Access Compliance Report

Public Rights-of-Way

(Curb Ramps)

Intersection ID: 28698	Main Street: OLD_LITTLE_ROCK_RD	Cross Street: HOOVER_CR	Location:	N/A
ADA ID: 9AAD0BFF63B2	Ramp Type: Perp	Initial Pass/Fail: Fail	Overall Compliance: No	Severity Score: 10
Codes/Mitigation Info/Possible Solution		Field Measurements/Component Compliance

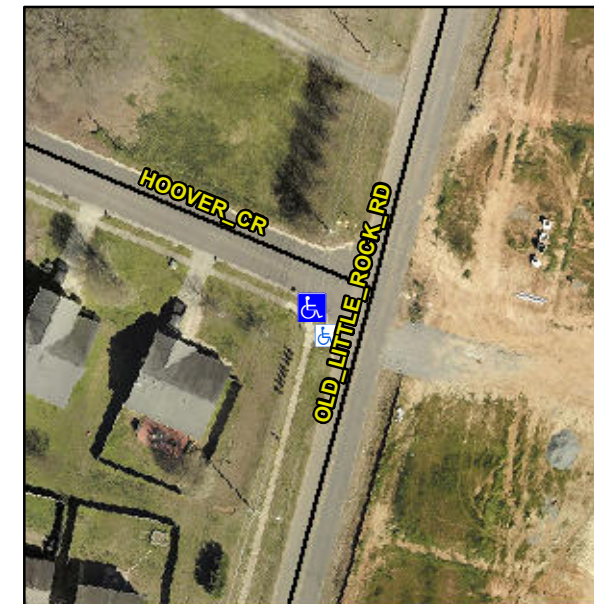
Not Found, R304.5.1, R304.5.3

Compliance	Description	Data	Compliance	Description	Data
N/A	Ramp Length (in)	46.0	Yes	Ramp Slope (%)	5.3
No	Ramp Width (in)	44.0	No	Ramp XSlope (%)	2.6
N/A	Flare Type LT	N/A	N/A	Flare Type RT	N/A
N/A	Flare Slope LT (%)	N/A	N/A	Flare Slope RT (%)	N/A
N/A	Flare Traversable LT?	N/A	N/A	Flare Traversable RT?	N/A
N/A	Landing Length (in)	N/A	N/A	DWS Provided?	N/A
N/A	Landing Width (in)	N/A	N/A	DWS Contrast?	N/A
N/A	Landing Slope (%)	N/A	N/A	DWS Length (in)	N/A
N/A	Landing X Slope (%)	N/A	N/A	DWS Full Width?	N/A
N/A	Landing Curb? (Y/N)	N/A	N/A	DWS Offset (in)	N/A
N/A	Shared Landing?	N/A			
N/A	Gutter Ponding?	N/A	N/A	Gutter Slope (%)	N/A
N/A	Gutter Lip Ht (in)	N/A	N/A	Gutter X Slope (%)	N/A
N/A	Painted X Walk1?	No	N/A	Painted X Walk2?	N/A
	X Walk 1 Direction	To N		X Walk 2 Direction	N/A
N/A	X Walk 1 Width (in)	N/A	N/A	X Walk 2 Width (in)	N/A
	X Walk 1 Slope (%)	4.0		X Walk 2 Slope (%)	N/A
	X Walk 1 X Slope (%)	0.3		X Walk 2 X Slope (%)	N/A

N/A	Ramp inside XWalk1?	N/A	N/A	Ramp inside XWalk2?	N/A
	Road Slope (%)	0.3	N/A	Clear Space?	N/A
	Road X Slope (%)	4.0	N/A	Clear Space to XWalk (in)	N/A
N/A	Any Obstructions?	N/A	N/A	Storm Grate/Utility Hazard?	N/A
	Obstruction Type			Storm Grate/Utility Type	
		N/A			N/A
			Yes	Surface Condition? (G/P)	Good

Remove & Replace Entire Ramp.
